ADDENDUM #02

INTERIOR RENOVATIONS & CLASSROOM ADDITION FOR: LAKE RIDGE ELEMENTARY SCHOOL

TFM Project No. 2021-03-24-03

May 28, 2021

MRS System 2000

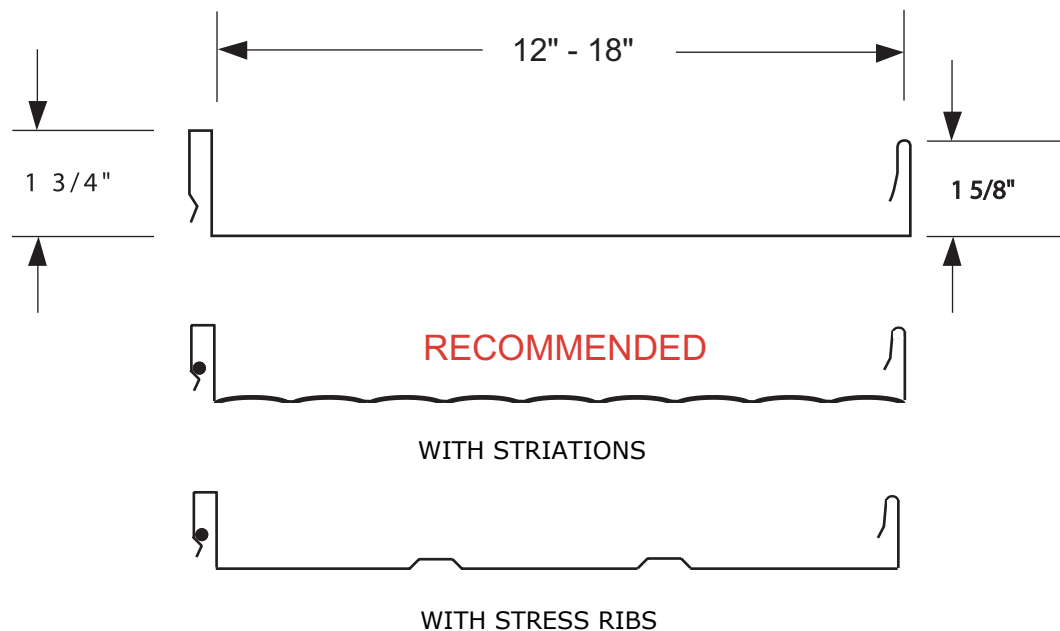
Proposed Substitution: **MRS SYSTEM 2000**

Proposed Substitution: **MRS SYSTEM 2000**

8. Refer to **07 4110 / 07 4113 / 07 7713, Section 2.1 Manufacturers**
 - a. Add ***Metal Roofing Systems*** as an acceptable manufacturer of a comparable product.

APPROVED

MRS Rapid-Lock Coping

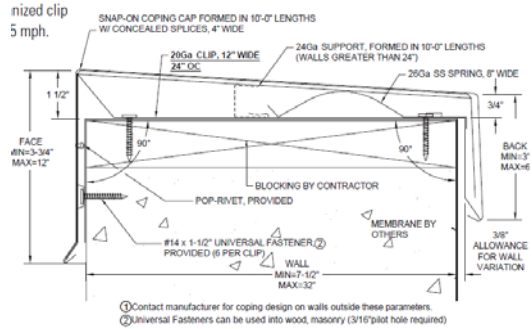
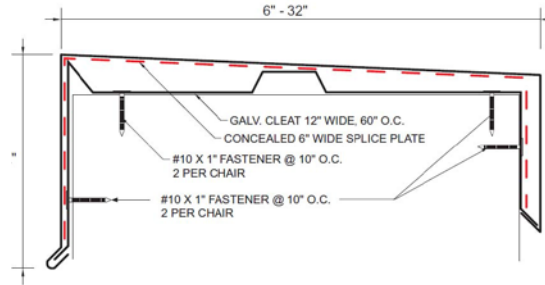
Proposed Substitution: **MRS RAPID-LOCK COPING**
